SANDY CREEK SOLAR FARM

PEER REVIEW OF SOLAR PHOTOVOLTAIC GLINT AND GLARE STUDY

**Prepared For
Wagga Wagga City Council**

DRAFT ISSUE: 01 November 2021

Figure 1 Site layout plan

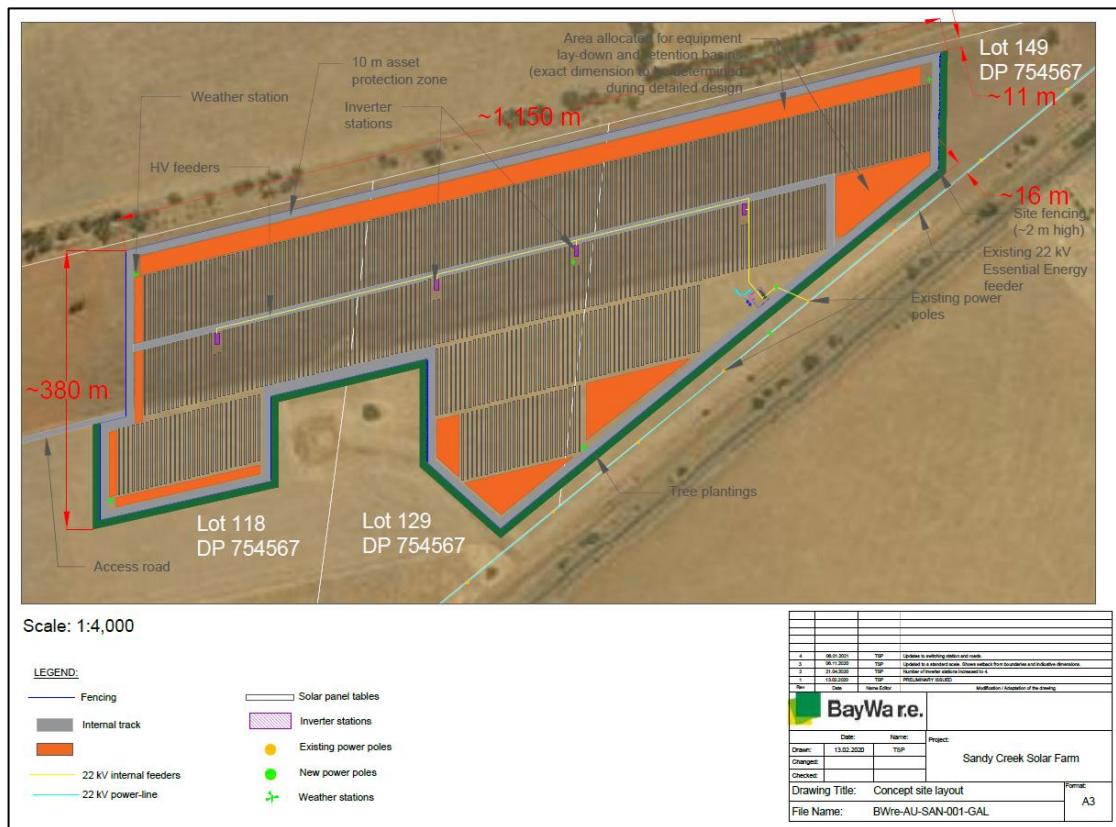
8.	Mitigation Measures - Tree planting was included in the site layout plan as a mitigation measure for visual and glare impacts - The study assumes the screen planting will be entirely opaque across its length and at sufficient height to eliminate views of the PV panels	a) No detail of the screen planting is provided in the study b) The Statement of Environmental Effects included under 'Safeguards and mitigation measures' (VA1) screening vegetation to a height of 3 to 4m within 8 years, and more than 1 row deep to block views. c) A landscape plan is to be provided prior to construction. d) The study did not address the glare hazard mitigation requirements prior to the vegetation screens becoming established sufficient to block glare (potentially an 8 year period). e) Mitigation of glare hazard could be managed in the short term through restrictions on the backtracking operation. f) In the long term visual screening of the Project will also screen glare and restrictions on backtracking would no longer be required.

- The Project Landscape Plan is to include vegetation screens, it is recommended these screens should be at minimum 5 metres wide and include a variety of plant species to provide a dense screen sufficient to block glare, to a minimum height of 4 metres. The vegetation screens should extend the full length of the eastern, southern, and western boundaries of the solar farm.
